## Staff Report to the Planning Commission

Application Number: **08-0106**

**Project Description:** The project proposes to re-contour, install drainage improvements, and revegetate approximately 600 feet of an unnamed ephemeral drainage that drains a large portion of the Santa Cruz Gardens subdivision. The project is designed to repair severe bed and bank erosion, prevent future erosion, provide some detention, and establish native riparian vegetation along the impacted drainage corridor. Several gabion drop structures would be constructed within the drainage corridor to allow for backfilling, re-contouring, and storm water detention that would enable the establishment of native riparian vegetation along the currently eroded drainage. A gabion energy dissipater would also be constructed at the downstream end of the project area to reduce the velocity of storm water flows in an effort to eliminate downstream erosion.

1 GABION APRON ENERGY DISSIPATER-A

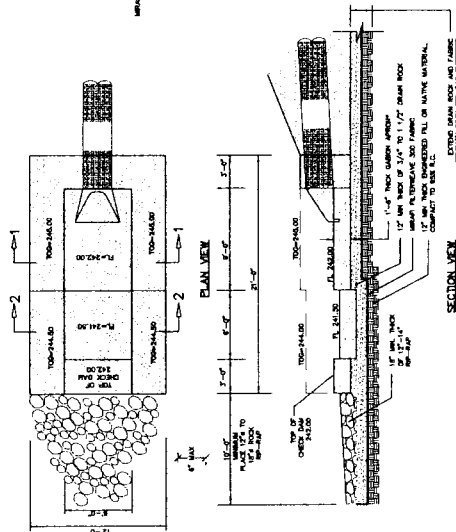
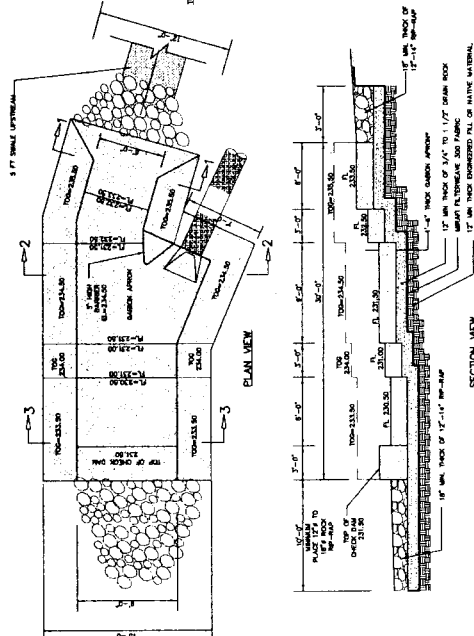
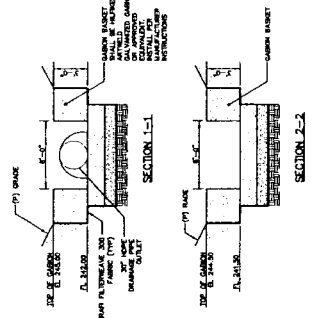
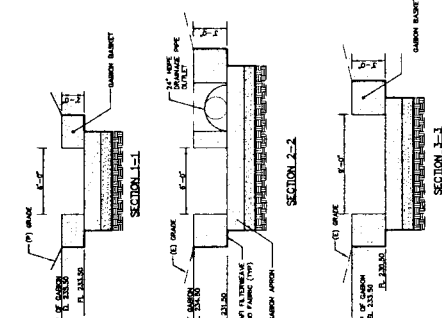
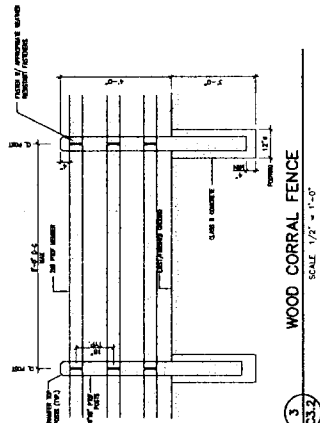
Sheet C3.2 - Detail 2 - please note is comments above (Sheet C1.0) regarding the opening of the upstream entrance of the dissipater to accept flows from the northwestern side tributary stream.
